## **Moving on Marion - Phase III Final Design**

### **Bike Winnipeg's Key Comments and Recommendations**

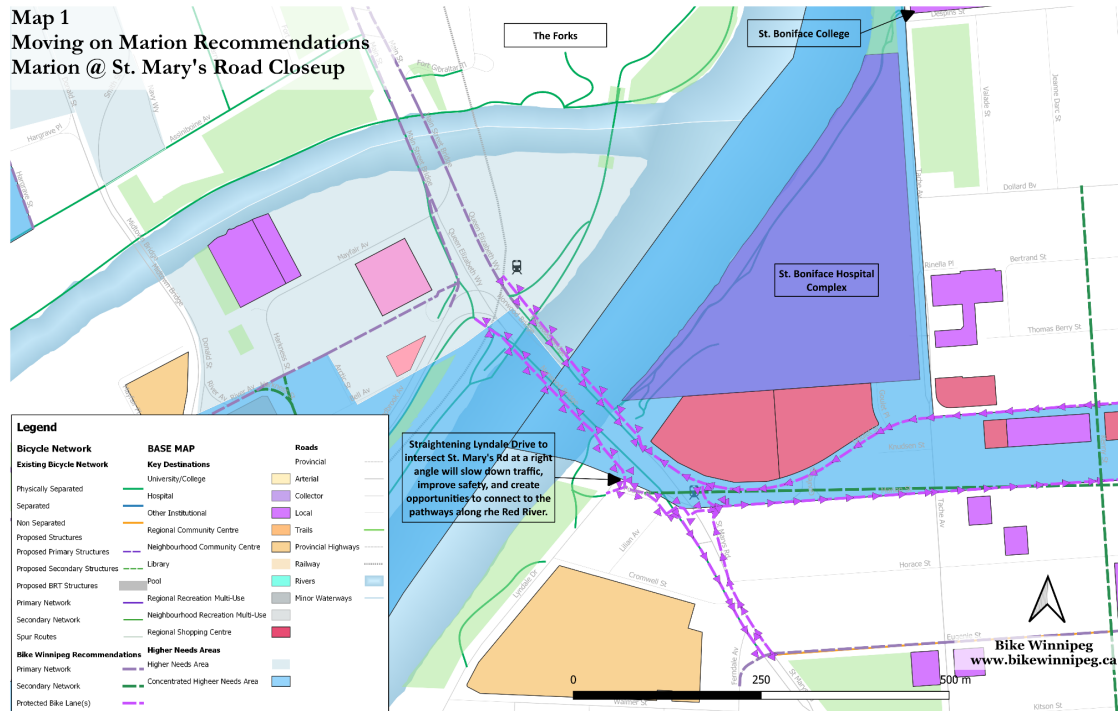
Two-way paths along two-way streets, especially busy streets such as St. Mary's, introduce a number of conflict points between people biking along the pathway and those driving motorized vehicles on the street. Conflicts between people making left turns off of the roadway and those biking in the contraflow lane of the bike path, who are generally out of the line of sight of those drivers as they focus on oncoming traffic, and riding at a much higher speed than people walking on the sidewalk.

What is the risk of having a two-way bike lane on St. Mary's Rd, and what is planned to mitigate the additional conflict points a two-way bike path adds?

- Is the access from NB St. Mary's Rd onto Cromwell being closed?
- Is the access from NB St. Mary's Rd into the Santa Lucia lot being maintained?
- What has been done to mitigate the threat from left hook collisions along the two-way St. Mary's bike path?
  - What is the offset distance of the bicycle path from southbound St. Mary's?
- If a two-way path is developed, an offset of 5 m plus raised crossings should be provided.

The following would seem to create almost all of the needed connections

- St Mary's Rd
  - Two-way bike path on the west side of St. Mary's Rd from Norwood Bridge to St. Mary's Rd crosswalk @ Marion
    - Route this along the west side of Poulin Dr and have it end at Lilian Ave.
    - You may need to reduce Poulin Dr to one lane at the entry to Lilian, but traffic counts on Poulin Dr are lilley low enough to allow for a signal lane access to provide two-way travel here.
    - Has the City measured turning volumes?
  - One way southbound from Lillian to Eugenie on the west side of St. Mary's
  - One way northbound from Eugenie to Marion on the east side of St. Mary's
    - This would follow the merge lane off of St. Mary's onto Marion, where it would connect with two-way bike paths leading across Goulet via the Dominion Mall entrance and south across St. Mary's to St. Mary's @ Lilian where it would connect with the two-way portion of the St. Mary's bike path.

## Protected Bike Lanes along Marion/Goulet Couplet

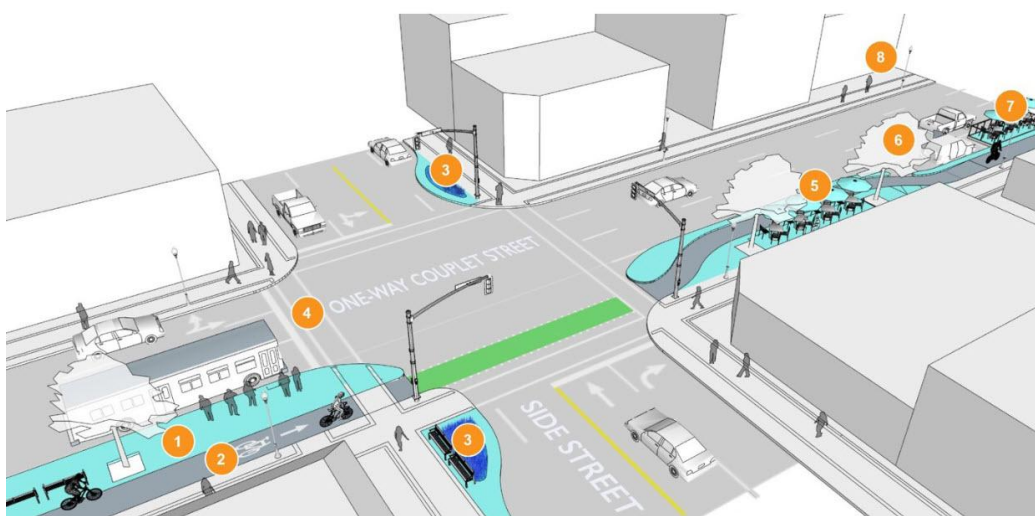
The complete street illustration provided on the 3rd board indicates that intersections are being designed as protected intersections, which we are happy to see.

Design of the bike protected lanes along Marion and Goulet will need to ensure that:

- Left turns from the protected bike lanes onto side streets are accommodated

- Include space for queue lanes where high rates of left turns might be expected
  - Enfield Cr
  - Braemar Ave
  - Kenny St

Proposed design for the River-Stradbrook protected bike lanes show how access between the Goulet bike lane and Braemar could be provided

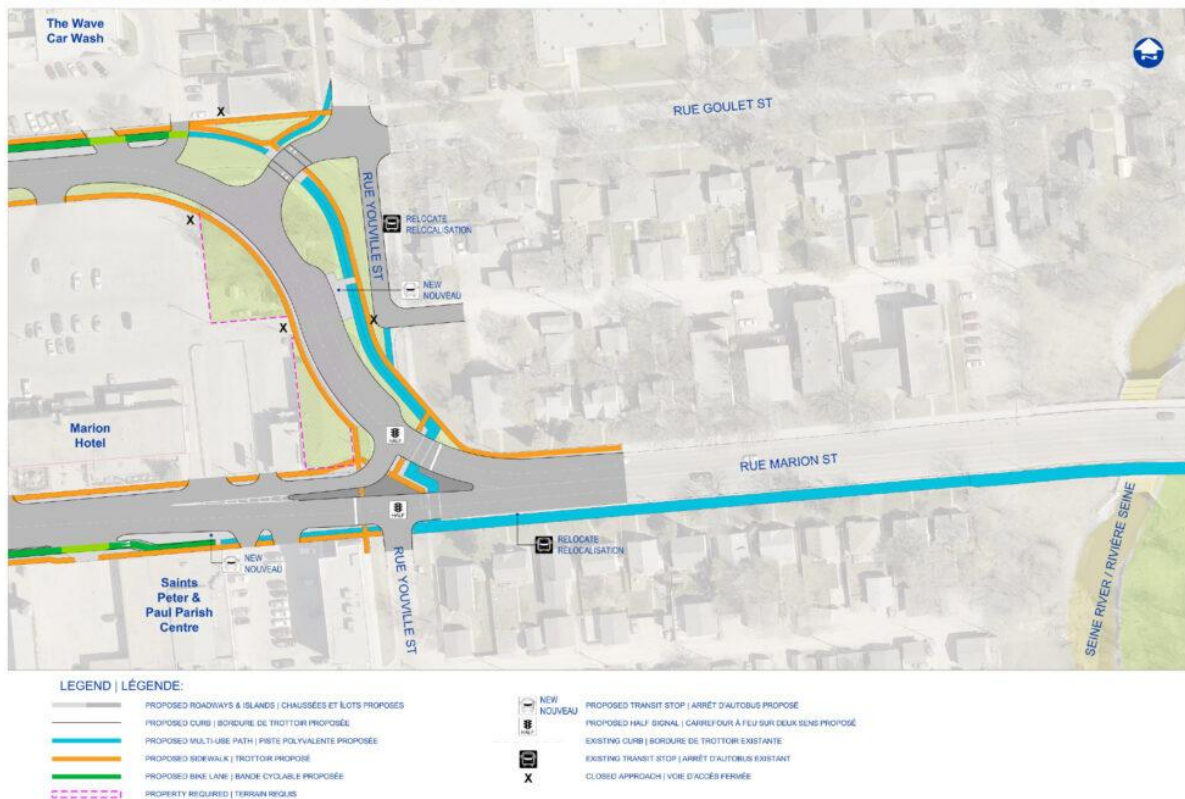
While Braemar Ave is not part of the cycling network at this point, it would be advantageous to provide a connection from the Safeway to the Goulet back lane to provide access between the Safeway and École Henri-Bergeron/Bertrand Arena. This could be accommodated via the walkway between Eiffel Tower A Apartments and the Columbus Manor parking lot. This is a 6m right of way.

Alternatively, you could provide a two-way bike path on the stretch of Goulet between Enfield and Bertrand to accommodate this traffic. Designs for the River-Stradbrook protected bike lanes show how both of these options might work.

At minimum, the connection off of Braemar onto the Goulet protected bike lane should be provided for. This intersection is currently signalized, so no or little change to signalization is required to accommodate this crossing.

People will ignore the detour to Enfield to/from Braemar to seek a direct route between these destinations, so we should recognize the desire and build to accommodate it. Failure to do so will just lead to people riding the wrong way down the Marion/Goulet bike lanes.

## Youville to Archibald

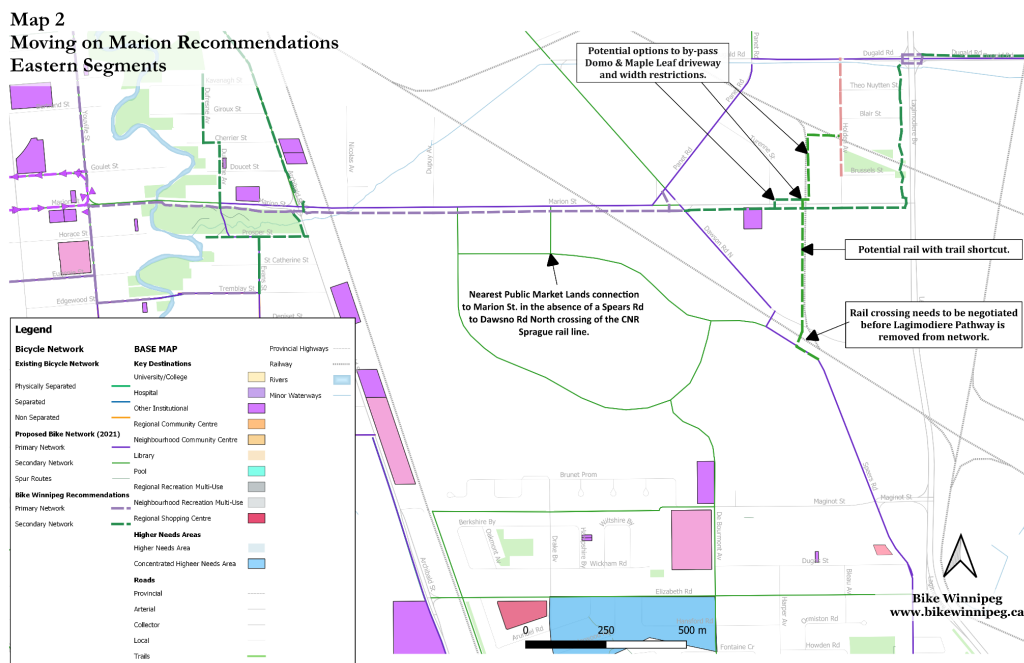
- We would like to see separation of pedestrians and bikes where space permits
- We would like to see raised crossings at driveways
  - It is good to see the hardened centre line treatment at the intersection of Marion and Archibald. This removes a considerable risk of left hook collisions at the entrance to the Tim Hortons.

- Domo-Maple Leaf width restrictions (and possible gap)
  - Could a crossing of Marion @ Turenne or the CNR Stockyards spur be used to alleviate this?
    - There appears to be a vacant industrial parcel running parallel to the rail line that might be used as a pathway north to connect into the Holden Neighbourhood. Assessment 6032188000, ID 183288

- It would avoid crossing the Domo and Maple Leaf parking lots, which would definitely be a benefit.
- Please ensure that the traffic signals at Marion and Dufrense can be activated by someone on a bicycle without having to access the sidewalk.
